MELBOURNE METRO RAIL PROJECT EES

Review of Noise and Vibration Aspects in Relation to 'The Botanica', 400 St Kilda Road

Ref. 11908-1ng.docx
12 August 2016

Figure A.35: Domain Station Precinct - Scenario A(i) - Predicted Noise Levels at 1.5 m above ground - construction activities to be undertaken during Normal Working Hours

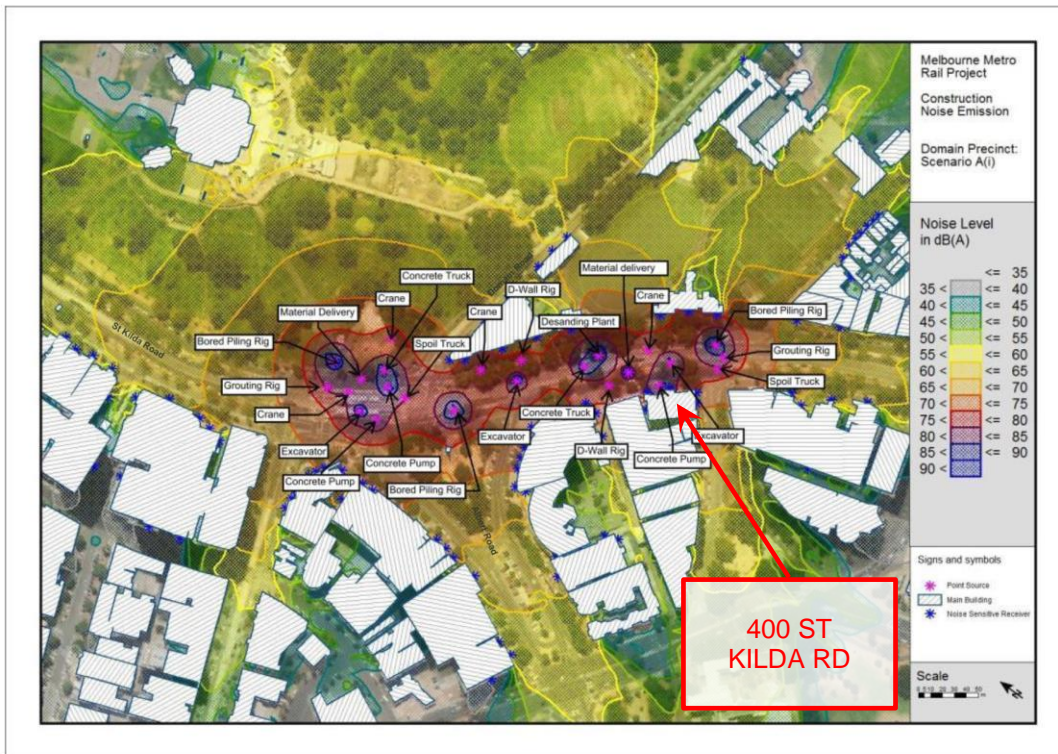
It is true that the EPA 1254 Guideline does not place restrictions on noise levels at residential premises arising from construction during normal working hours, but this figure indicates that the St Kilda Rd façade of 400 St Kilda Rd will be exposed to levels above 80dB(A).

There has not been a good indication given of the duration per working day or in terms the number of days, weeks or months that noise levels of this magnitude would be present.

This understates the impact that will occur at 400 St Kilda Rd: Figure A35 indicates levels above 80dB(A) on the façade of 400 St Kilda Rd. 6m high barriers reduce the resultant noise level at 1.5m above the ground, but 400 St Kilda Rd comprises 9 levels – anything above the first two levels will receive negligible attenuation from a 6m high barrier and be exposed to 80dB(A)+, which is very different to the 64dB(A) L_{eq} during the day baseline level, not ‘marginally higher’.

Such high noise levels would have a significant impact on residents, so it is important that the expected duration of this stage is made clear in order to fully understand the magnitude of the impact and assist residents in making decisions regarding actions that may be taken.

Figure A.37: Domain Station Precinct - Scenario B - Predicted Noise Levels at 1.5 m above ground - construction activities to be undertaken over 24 hours Unavoidable Works. Note: locations of sheds are indicative only.

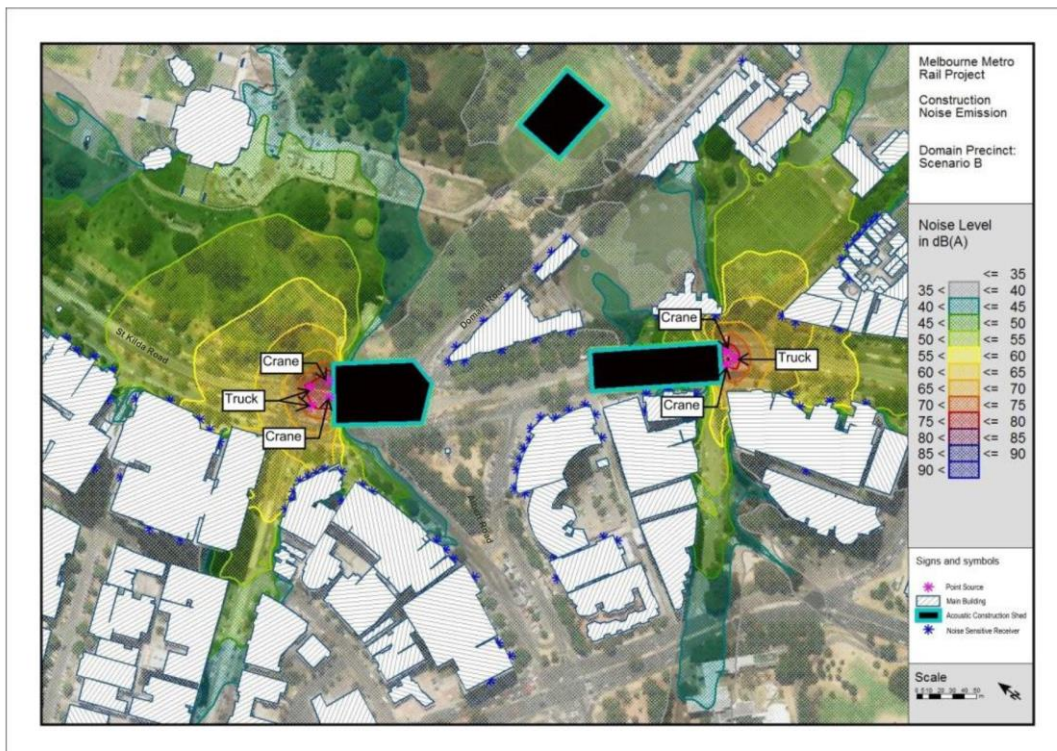
Acoustic attenuation sheds are described and figure A.37 below shows acoustic attenuation sheds in place for unavoidable works to be undertaken 24 hours per day, but there is a lack of clarity regarding how/where these sheds fit in with the excavation of the entire Domain site, which would presumably precede the installation of the sheds.
